CNL-17-001

Subject: **Sequoyah Nuclear Plant, Units 1 and 2, License Amendment Request to Revise Emergency Plan Staff Augmentation Times**

**ENCLOSURE 1**  
**SEQUOYAH NUCLEAR PLANT**  
**UNIT 1 and UNIT 2**  
**Evaluation of Proposed Changes**

License Amendment Request to Revise Emergency Plan Staff Augmentation Times

**Figure B-1  
SITE EMERGENCY ORGANIZATION  
(Including Minimum Staffing and Augmentation) (See Note 1)**

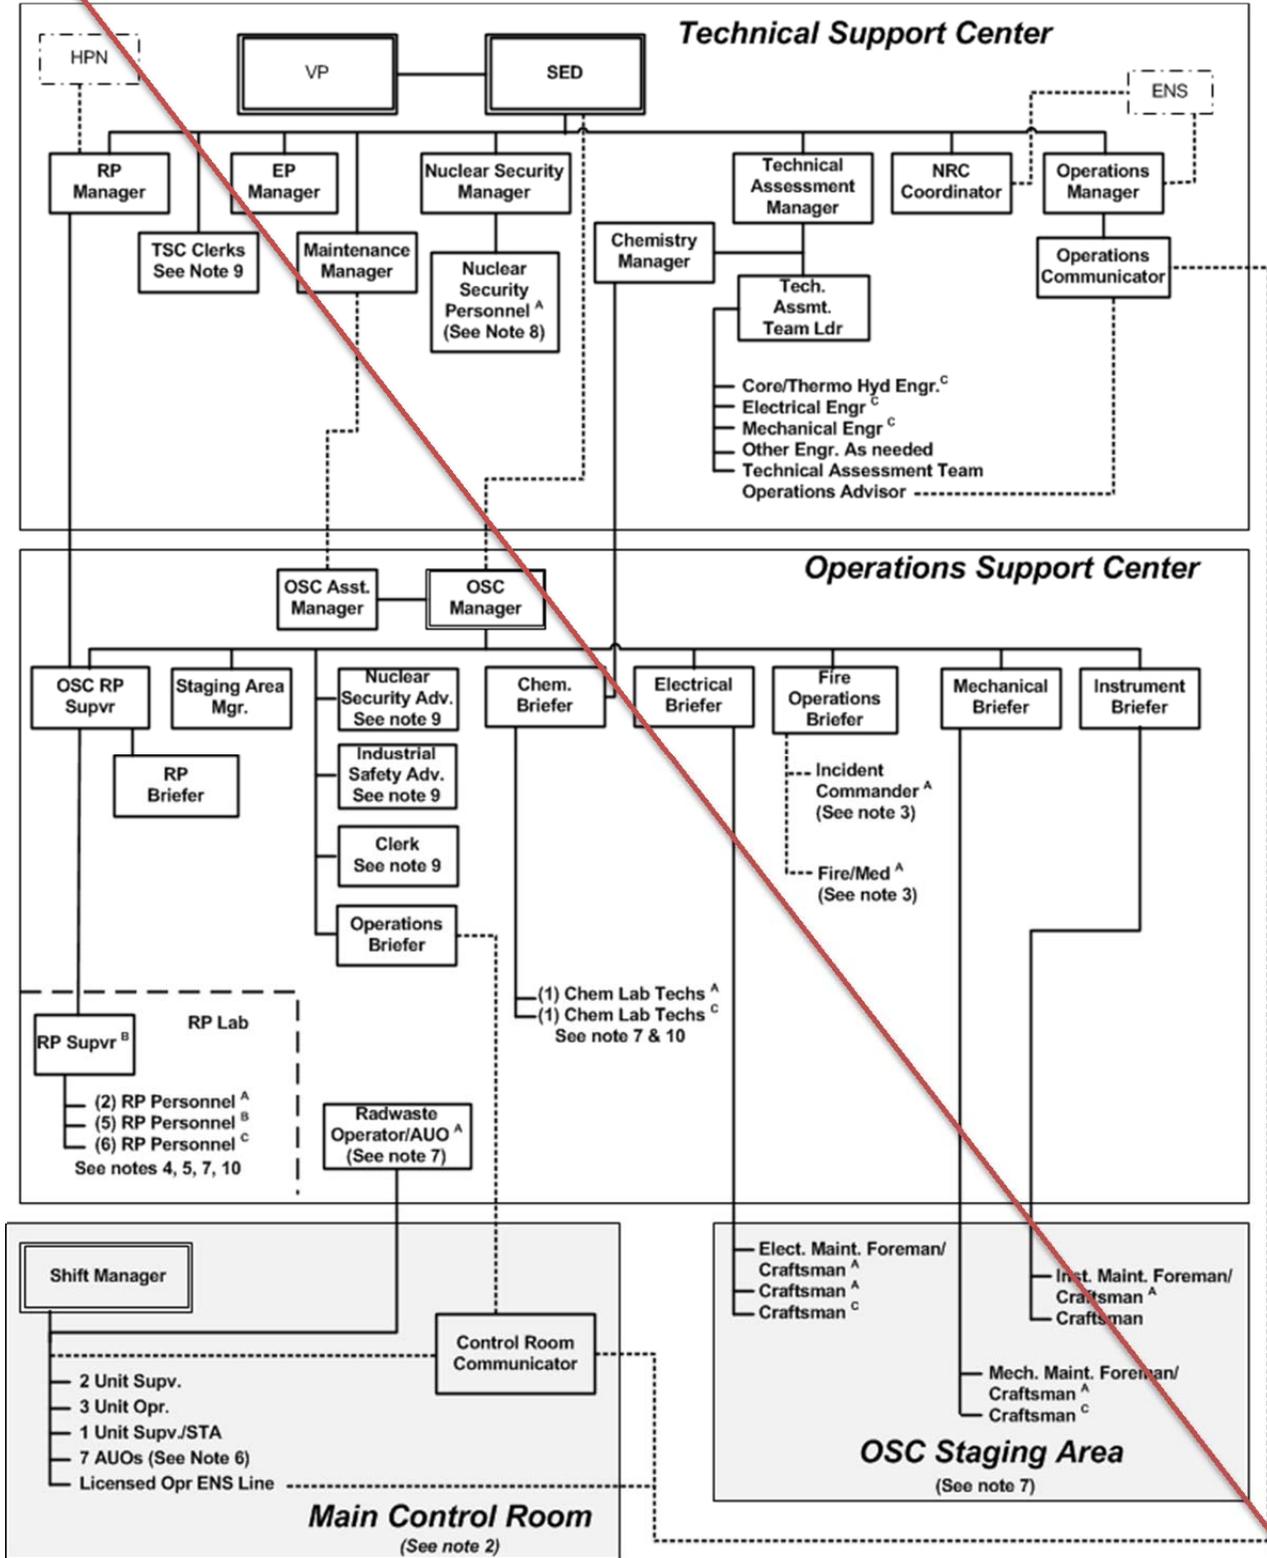
- p. Appendix B, Figure B-1, "Site Emergency Organization," replaced figure with revised version in accordance with proposed change.
- q. Appendix B, Figure B-1, "TSC and OSC Emergency Organization," revised figure to reflect TSC and OSC augmented positions, minimum staff required for activation of each facility, and removal of 'as needed' positions.

The proposed revision to SQN Emergency Plan Appendix B, Figure B-1, identifies MASP in the TSC and OSC, which support activation of the facilities within 60 minutes of an Alert or higher classification as:

**FIGURE B-2  
MINIMUM ONSHIFT RESPONSE PERSONNEL**

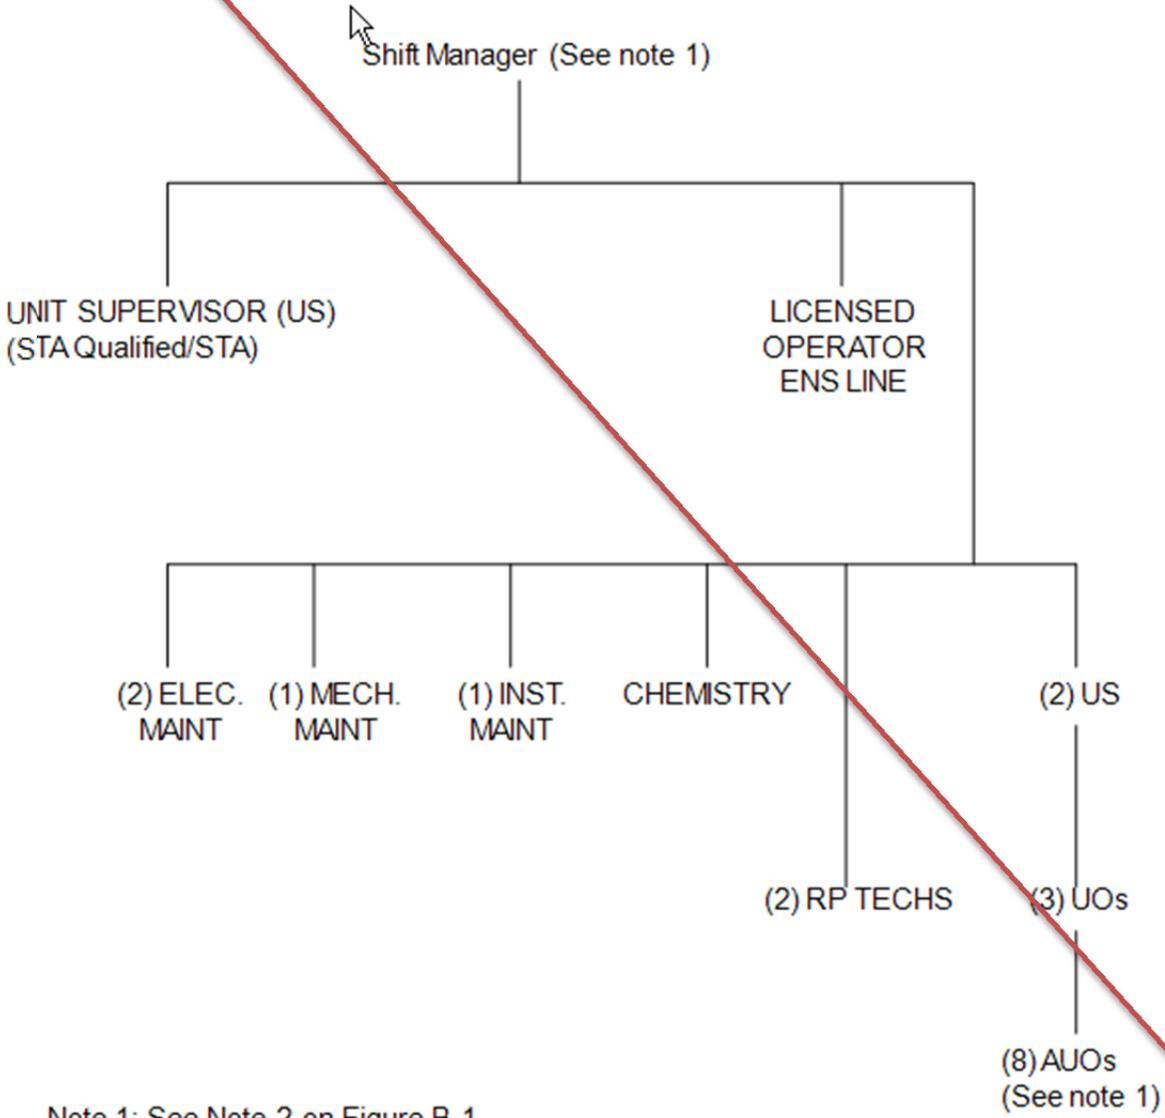
- r. Appendix B, Figure B-2, "Minimum On-shift Response Personnel," figure replaced with revised version in accordance with proposed change.
- s. Appendix B, Figure B-2, "Minimum On-Shift Response Personnel," revised figure to more closely reflect on-shift and augmented positions in format similar to NUREG-0654 Table B-1.

In the proposed Emergency Plan, Figure B-2 has been reformatted to more closely align with NUREG-0654, Revision 1, Table B-1. Additionally, Figure B-2 includes augmented response positions that are credited with command and control functions as defined in the Emergency Plan. The total number of on-shift staff continues to exceed NUREG-0654, Revision 1, Table B-1 values. As stated in Section 3.1, an on-shift staffing analysis determined that the proposed changes did not result in conflicting duties for on-shift staff. Therefore, the proposed increase in augmentation times will not detract from the capability of on-shift personnel to support plant operations or the assessment of operational aspects major task.

**Figure B-3  
TECHNICAL SUPPORT CENTER (SAMPLE)  
Control Building Elevation 732'**

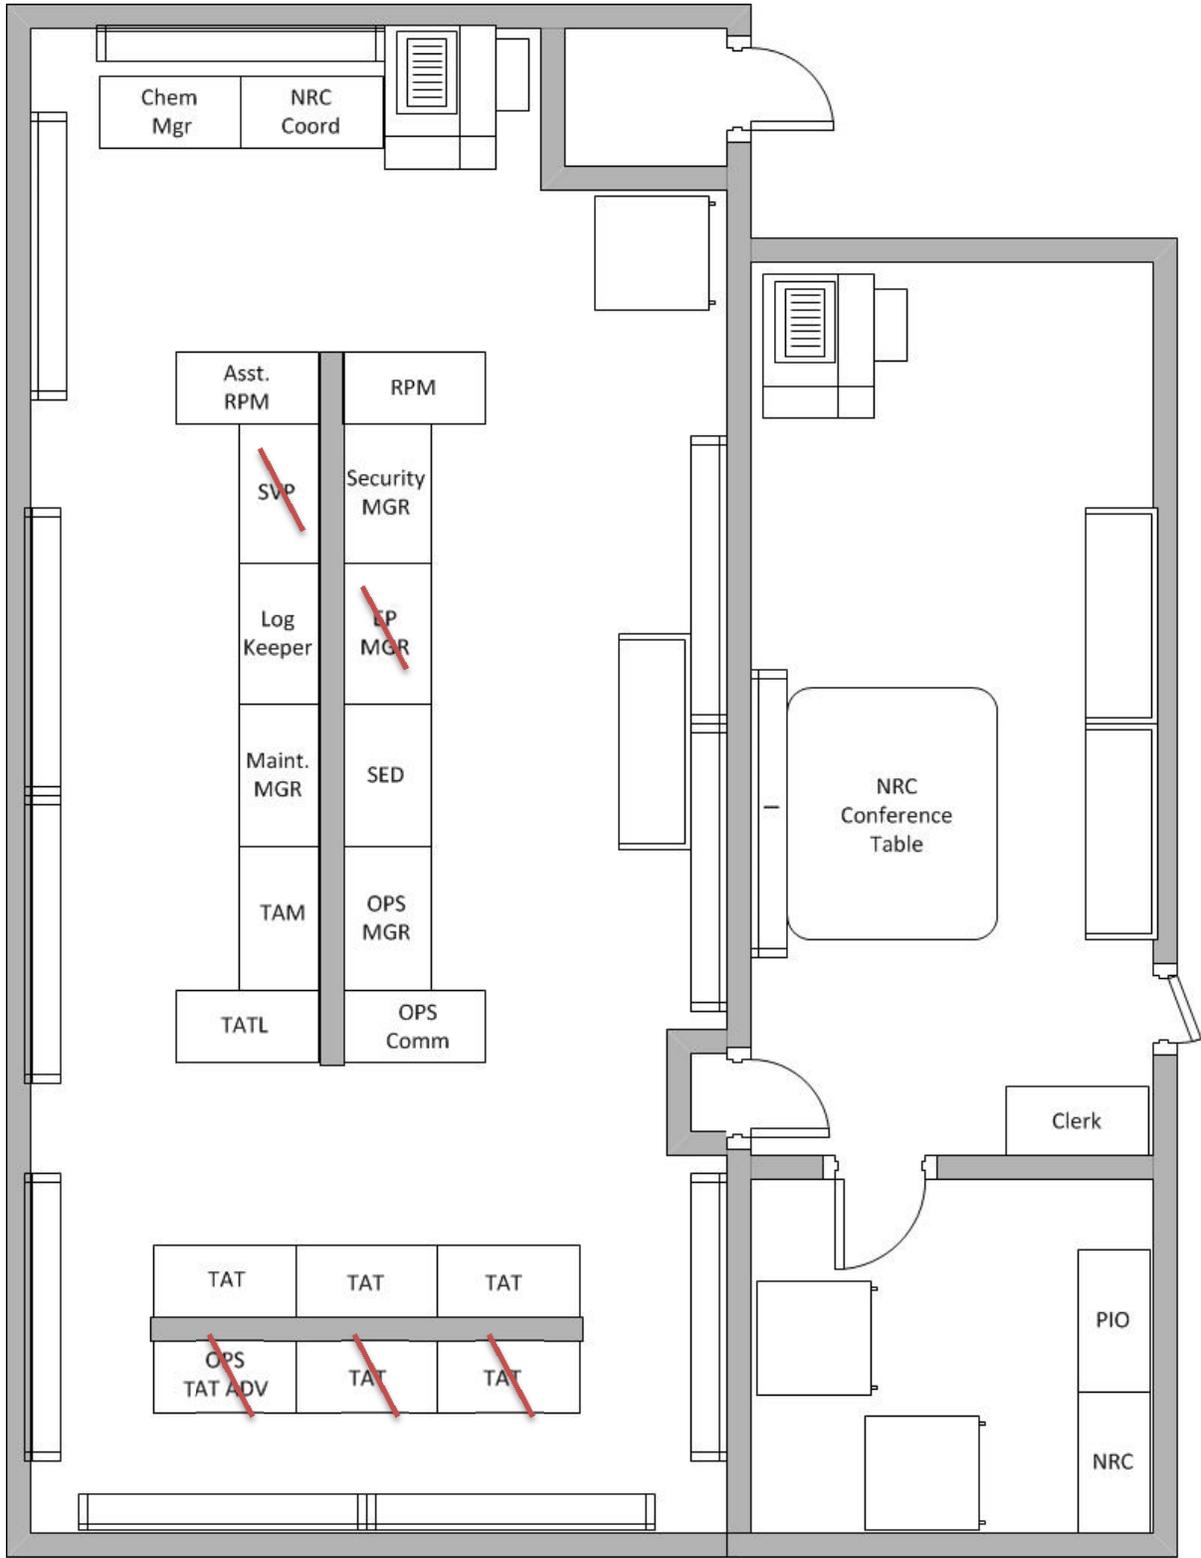
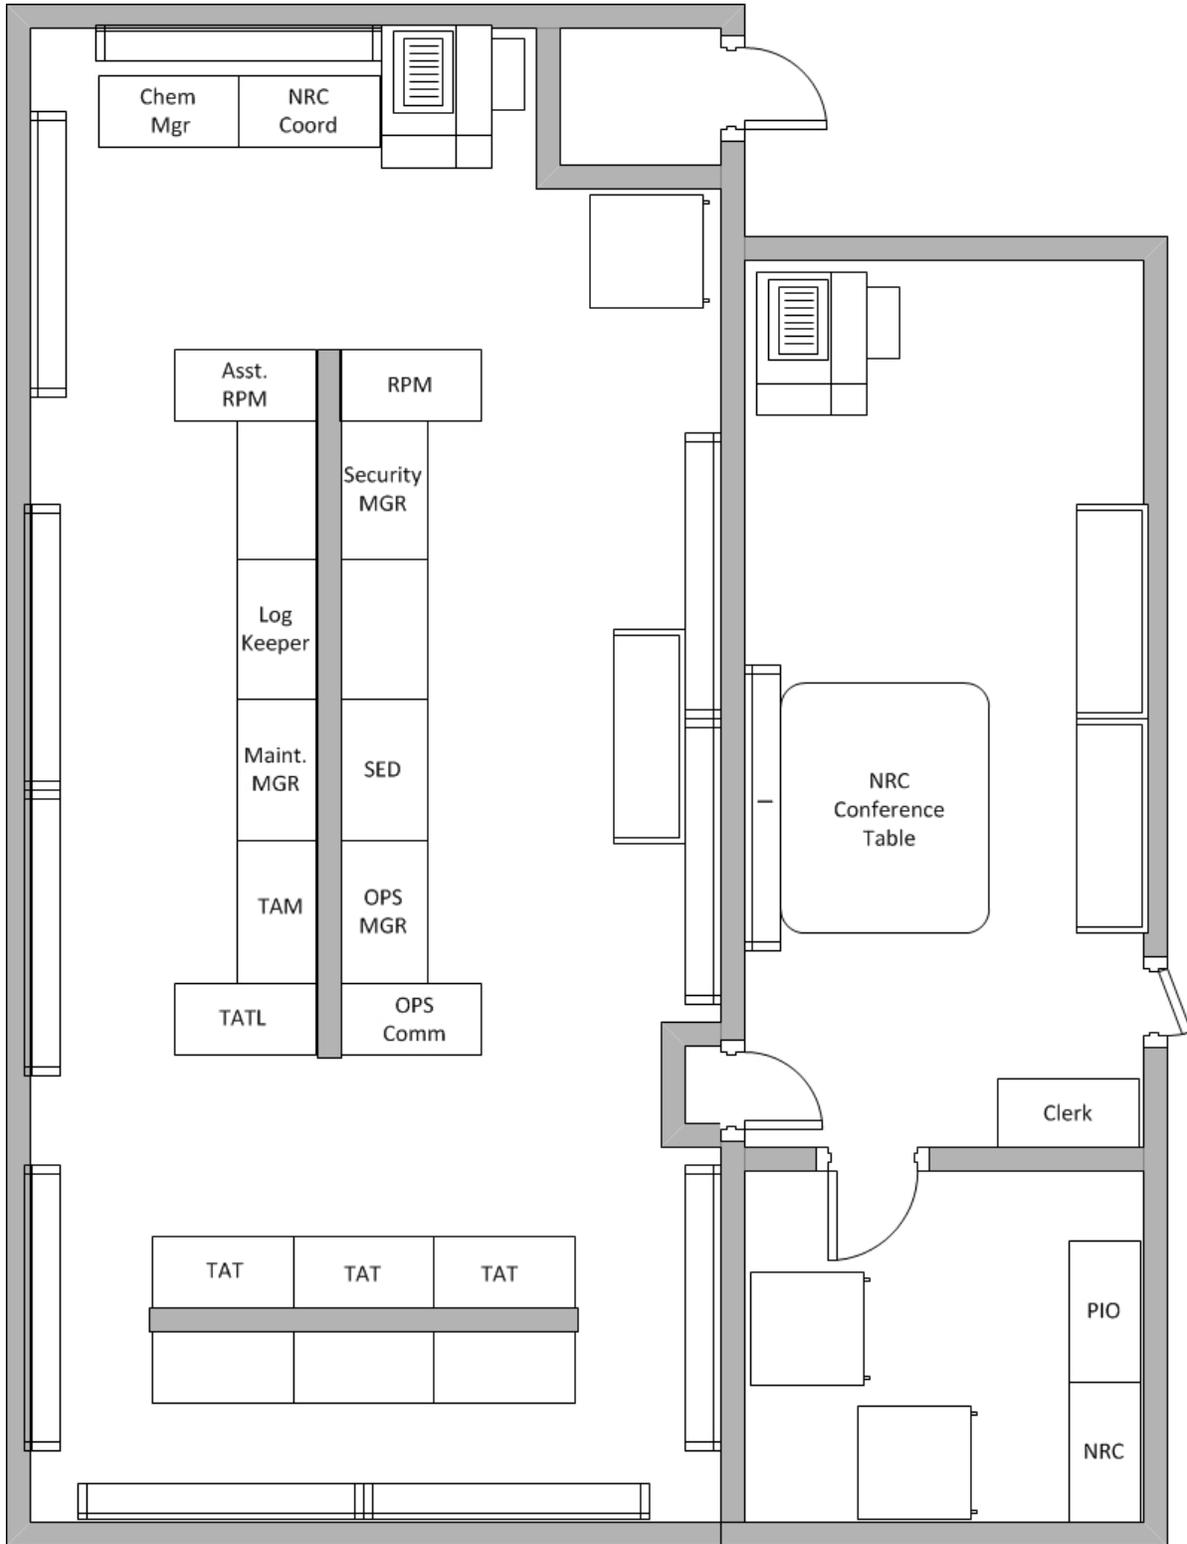
- t. Appendix B, Figure B-3, "Technical Support Center," revised to reflect removal of support positions not required for implementation of the Emergency Plan and added 'Sample' to title to identify acceptability of other facility configurations as needed.

**FIGURE B-4  
OPERATIONS SUPPORT CENTER (SAMPLE)  
Plant Office Building Elevation 706**

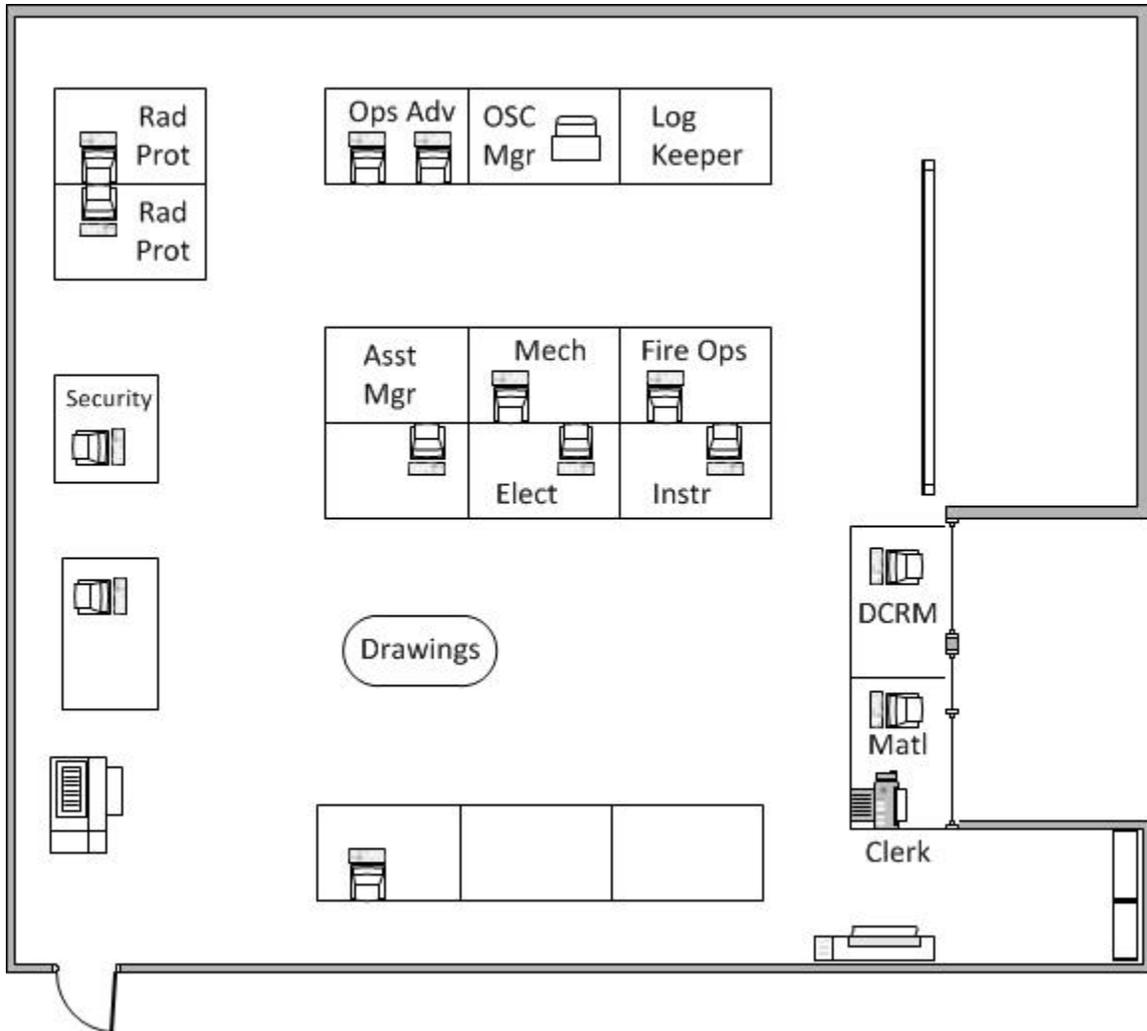
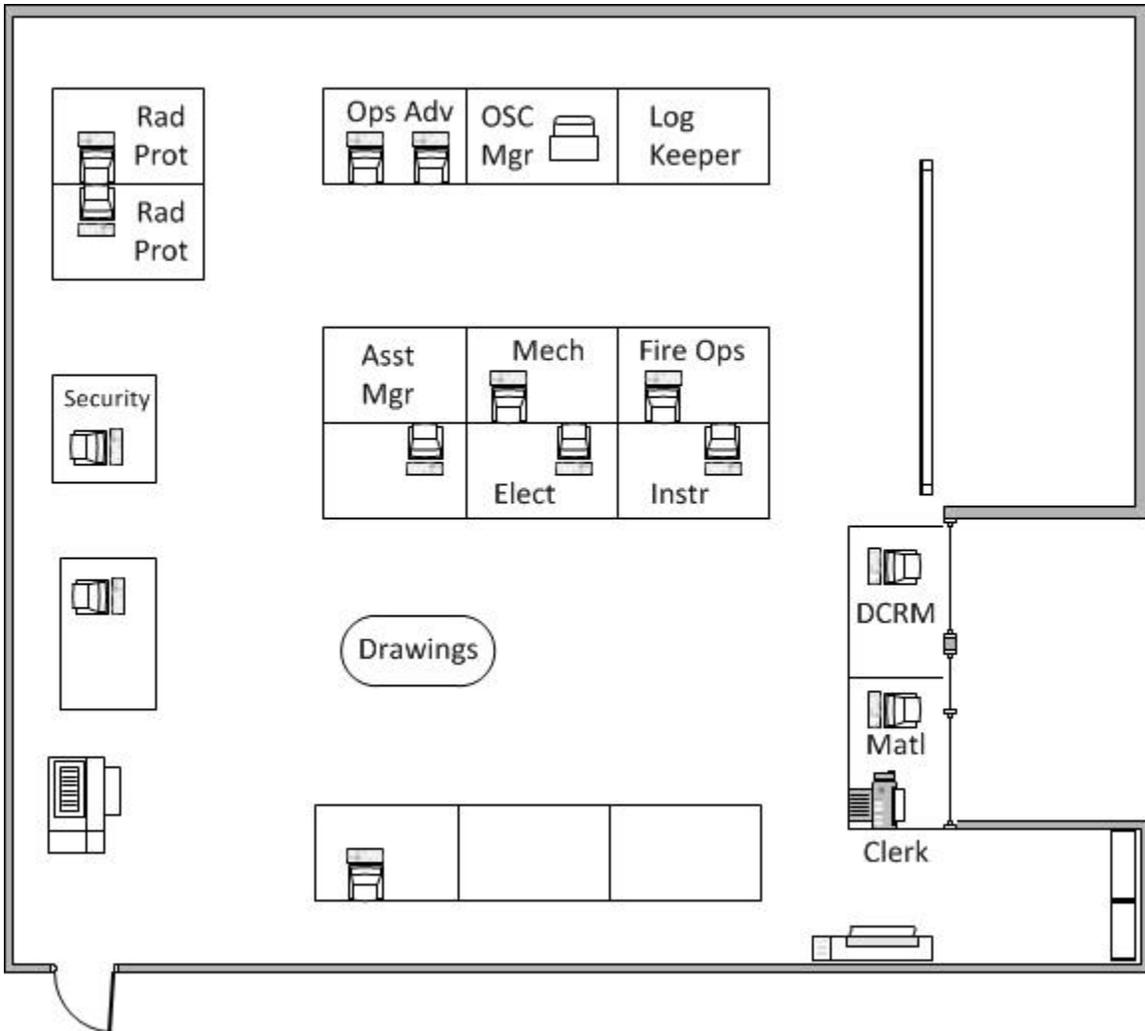
- u. Appendix B, Figure B-4, "Operations Support Center," revised to add the word 'Sample' to title to identify acceptability of other facility configurations as needed.
